POLICY REPORT  
DEVELOPMENT AND BUILDING

Report Date: October 4, 2016  
Contact: Susan Haid  
Contact No.: 604.871.6431  
RTS No.: 11681  
VanRIMS No.: 08-2000-20  
Meeting Date: October 18, 2016

TO: Vancouver City Council  
FROM: General Manager of Planning, Urban Design and Sustainability  
SUBJECT: CD-1 Rezoning: 7638-7664 Cambie Street

Figure 2 – Site Plan

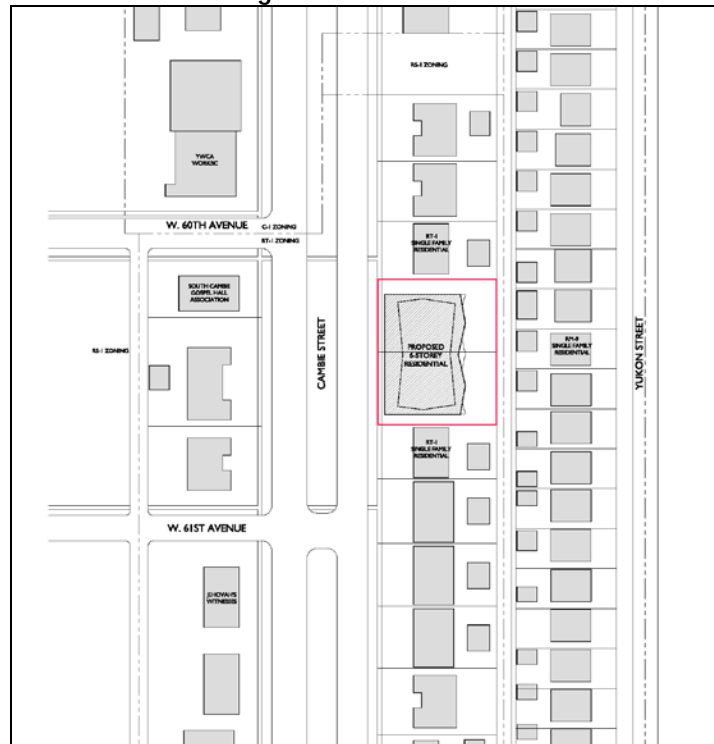
- 1. Design development to increase the front setback by an at least 3 ft.

Note to Applicant: Because the continuous front balconies will read collectively as building mass, the building should be set back to satisfy the intent of the 10 ft. minimum front yard setback. The rear yard setback can be decreased by an equivalent amount to maintain general building configuration.

- 2. Design development to introduce grade level openings into the north elevation.

Note to Applicant: At midblock linkages, ground floors should have an active edge with entrances and windows facing the pedestrian pathways.

- 3. Design development to delete the two massing enclosures on the roof.

Note to Applicant: The proposed rooftop enclosures capture floor area intended for private residential use, and would therefore constitute a seventh storey. Modest rooftop enclosures can be considered to accommodate access to the green roof and storage of maintenance equipment for the green roof, but not for residential use. Residential access to the roof should be accommodated by discrete roof hatches. The kitchens and residential washrooms on the roof should be deleted or relocated to level six.
